REMARKS

In the Office Action mailed August 11, 2003:

FIG. 1

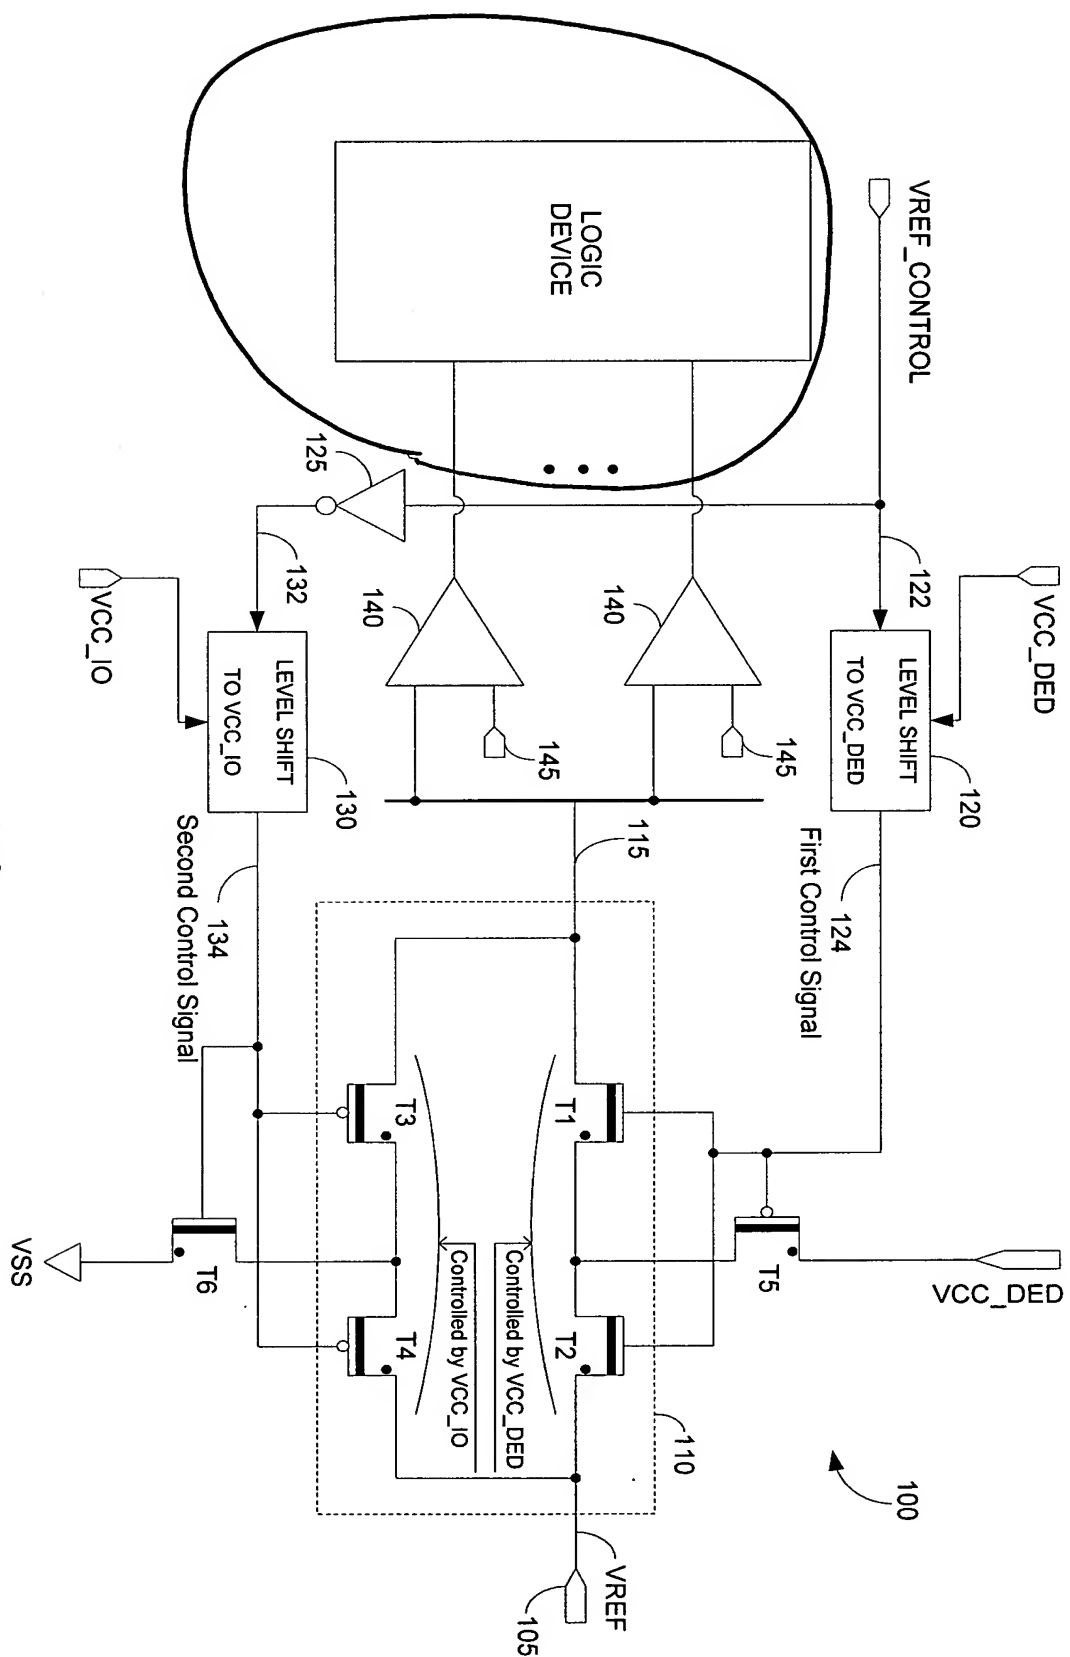
The Examiner also contends that claims 11 and 20 appear to be misdescriptive because Fig. 1 shows that the master control signal (VREF_CONTROL) is unrelated to the logic device (140) and that the limitation "the first supply signal is a core supply signal" in claim 11 makes no sense because "the first supply signal" and "the master control signal" refer to the same entity as recited on lines 2-3 of claim 8.

Element 140 is an input buffer that supplies signals to the logic device. To clarify this, Fig. 1 has been amended as circled in red to add a box labeled "logic device". This amendment is supported by the specification at page 6, line 31. Claims 8 and 11 have been amended to delete the reference to the first supply signal and to specify in claim 11 that the logic level is determined by a core supply signal.
